Three Kings Renewal

Response to Auckland Council Feedback on Draft Private Plan Change Application - Option H1

Table 1 – Responses to AC feedback

TYPICAL HIGHWALL SECTIONS FOR ASSESSMENT

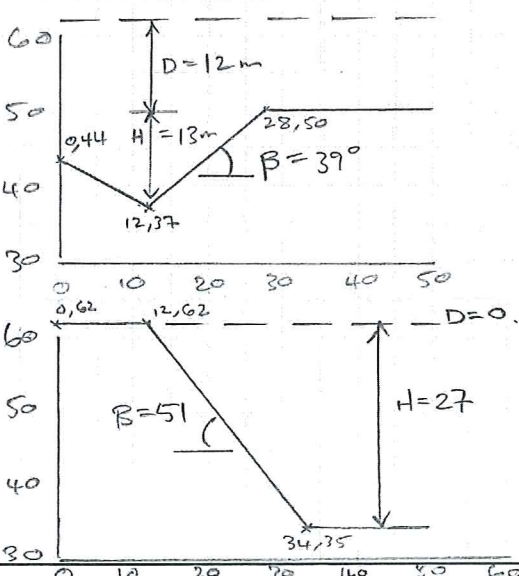
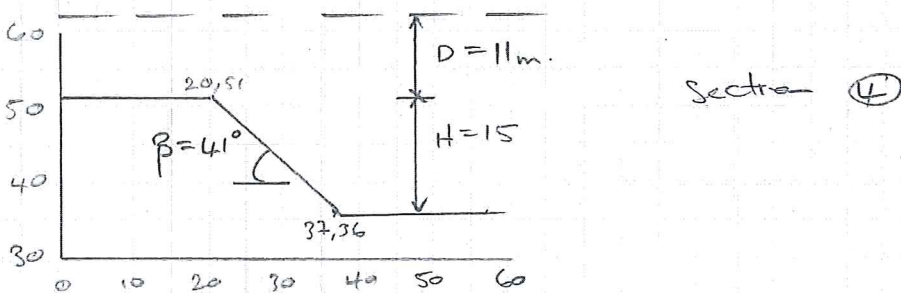
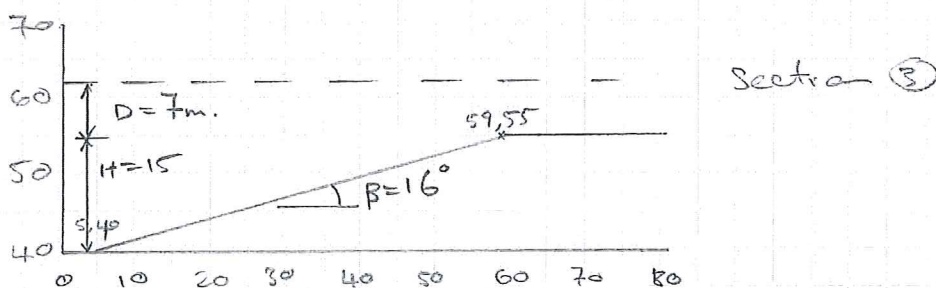
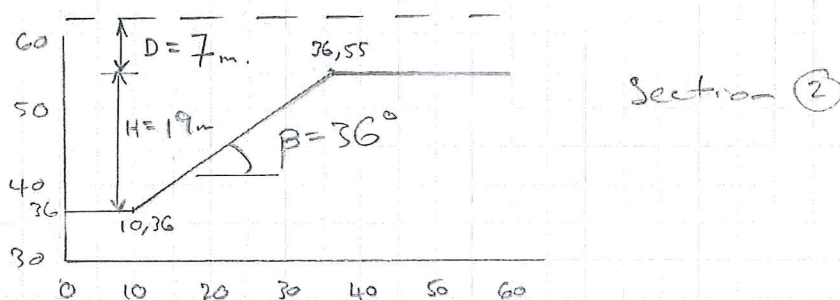
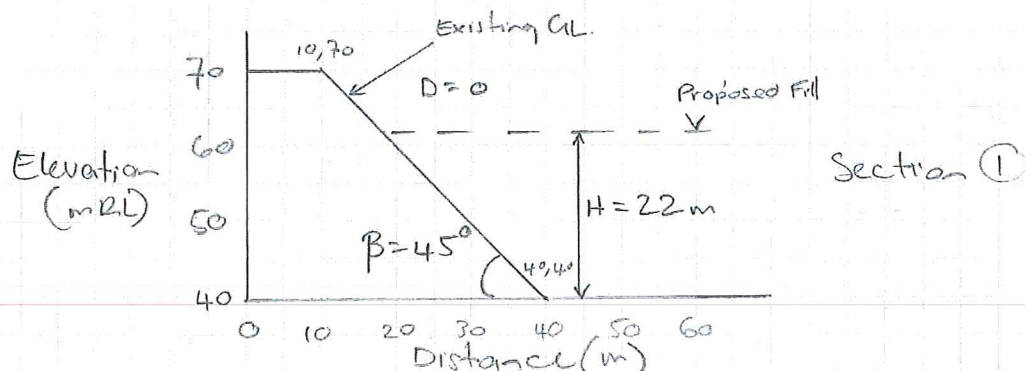
Item(s)	Auckland Council Feedback on Fletcher Residential Draft Private Plan Changes	T&T Response	Reference
80	Confirmation that it is practical to place imported fill to the engineered standard required given expected variable composition and the challenges of confirmation testing.	<p>The detailed earthworks specifications include identification of suitable and unsuitable soils together with conditioning, placement, compaction and verification testing regimes.</p> <p>As part of the specification, one criteria for acceptance of fill to the site is its ability to be conditioned and compacted to achieve the required engineering performance standards.</p> <p>Fill placement methods and testing procedures to confirm that the fill</p>

Item(s)	Auckland Council Feedback on Fletcher Residential Draft Private Plan Changes	T&T Response	Reference
		<p>meets the required performance standard are part of the specification, and further specific methods and tests may need to be adopted during the course of the filling operation to match the specific characteristics of the fill.</p> <p>Such approaches have been used elsewhere for residential land development sites (such as the old Mt Wellington Quarry) to ensure that the fill placed provides appropriate support to land utility for structures, while also ensuring effective use of available resources.</p> <p>Measures currently in place at site are consistent with the requirements of the existing consent with respect to engineering requirements for fill placement.</p>	
81	The T&T Reports indicates that checks and analysis have been undertaken on long-term and differential settlements, however analysis has not been provided to confirm this.	The calculations referred to in the reports are appended to this letter. The calculations assume that the complete fill depth will comprise cohesive soil fill. Inclusion of other fills types, such as rock or crushed concrete would reduce the magnitude of settlement estimated in the calculations. On this basis, we consider the estimates to be conservatively based.	T&T report section 3.3.1. Calculations Attached as Appendix A

The final conclusions are based on typical highwall sections around the site. It should be noted that the Section 3 case is not typical of sections elsewhere on the site. This area has a lower wall angle (less critical) and therefore the compaction criteria determined for the other sections will be sufficient to control differential settlements at this location also.

Given a standard level of compaction control and a high level of control on the material quality is should be feasible to achieve a differential settlement above the buried highwalls of 1:500.

To achieve the differential settlement target of 1:1000 or better, a high level of compaction control and material selection will likely be required.

GENERIC FILL TRANSITION CROSS SECTION – OPTION 1
NOT TO SCALE

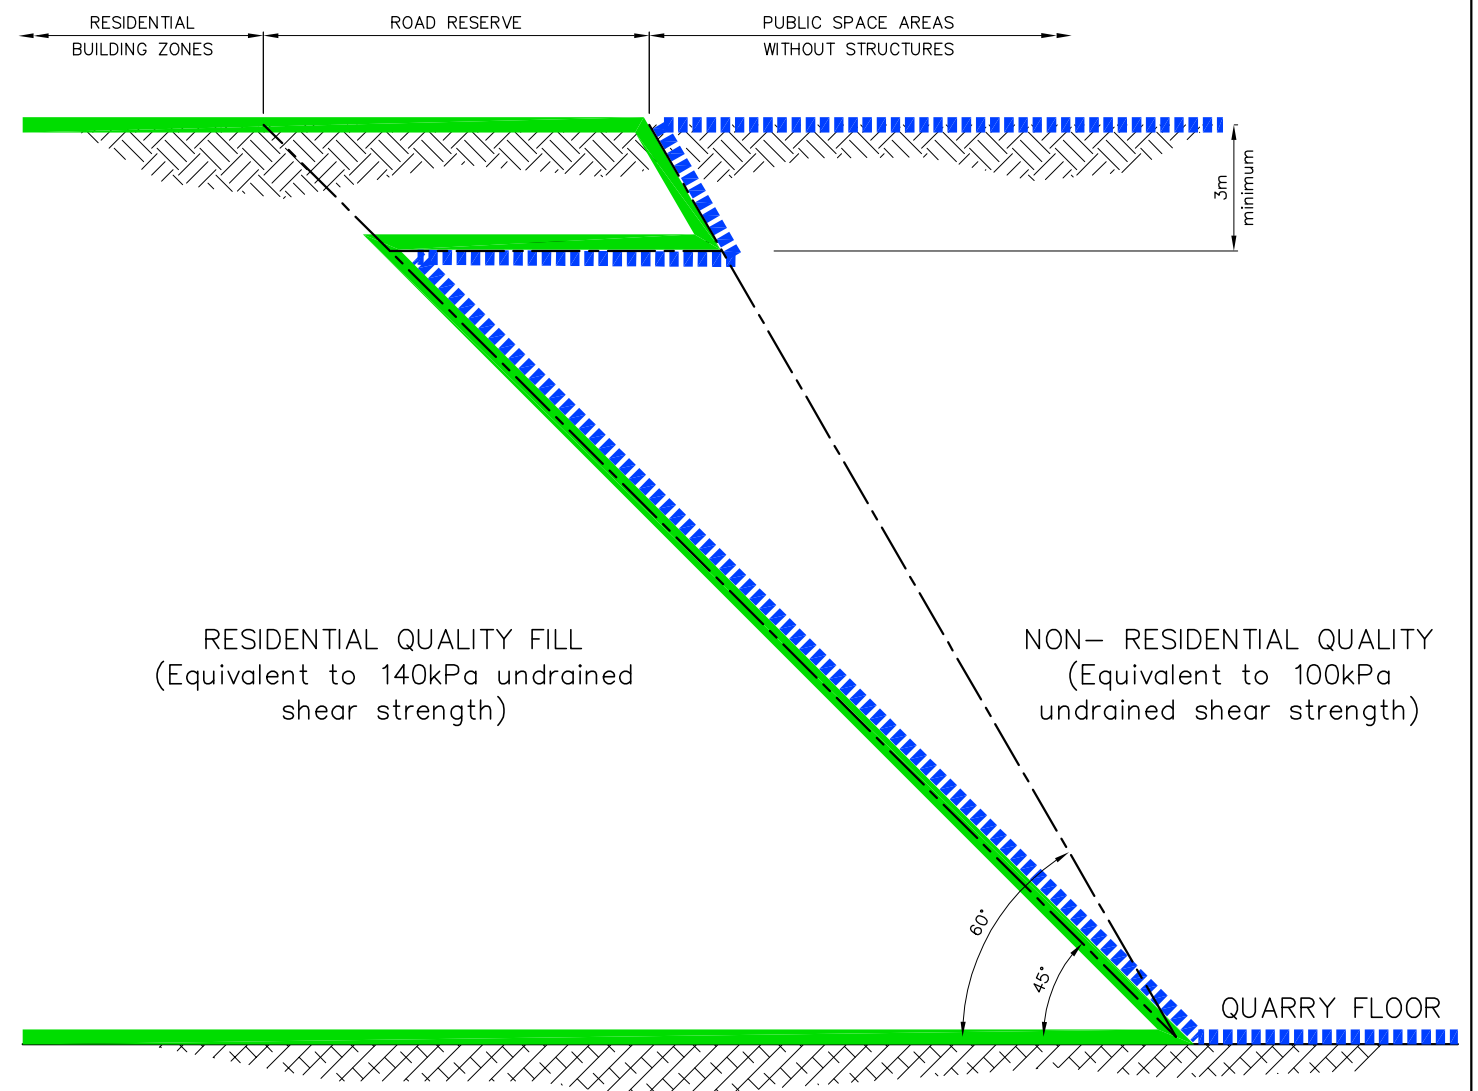
82	The reports note that the open space and parks do not have to be placed to the higher engineered standards. The last paragraph of Section 3.1 states "For Option 15H-1 (and similarly for Option 15H-2 in the other T&T report) the fill criteria for public space areas have been set to ensure the fill supports the intended land use ... settlement does not disrupt surface drainage features of playing fields." No details of the criteria appear to have been provided.	The filling criteria for public space areas will require performance equivalent to an undrained shear strength of 100kPa. This could be achieved through placing the material to this specification, or to an alternative specification with allowance for surcharging to induce settlements prior to final surface formation.	T&T report section 3.1
83	The depth of fill is significant (particularly for Option 15H-1) with the side by side playing fields adjacent to future residential development (to north and possibly south, depending on levels of filling to south), the outer margins of the playing field fill will also need to support the residential area and also need to avoid drag down effects. Therefore higher fill standards would be required within	Generic fill transition details have been developed to address this potential issue. These sections are appended to this letter and demonstrate two options for how the transition could be treated to minimise differential settlement, while also ensuring adequate support for the residential land.	Generic fill transition details attached as Appendix B

Item(s)	Auckland Council Feedback on Fletcher Residential Draft Private Plan Changes	T&T Response	Reference
	these outer portions of the playing field. This may result in an increased risk of differential settlement across playing fields. The effects of varying engineered fill standards and transitioning across the area needs further consideration.	Once actual fill sources and construction timeframes have been identified, the need or otherwise to mitigate the potential for adverse differential settlements in this zone can be assessed with greater certainty. Options to mitigate the potential for adverse differential settlement could include surcharging of the playing field fill to induce settlement prior to final surface formation.	
84	Clarification is required of what the groundwater levels will be maintained at and its effects on the lower fill layers.	The engineering fill specification excludes water sensitive materials, and requires material to be placed in thin layers with compaction to limit the potential for fill to take up water if regional groundwater level rises with the intention of minimising potential inundation settlement effects to be less than minor. Refer to PDP response for confirmation of groundwater level controls for the proposed development.	Refer T&T report section 3.4, para 4.

Fill transitions – generic sections
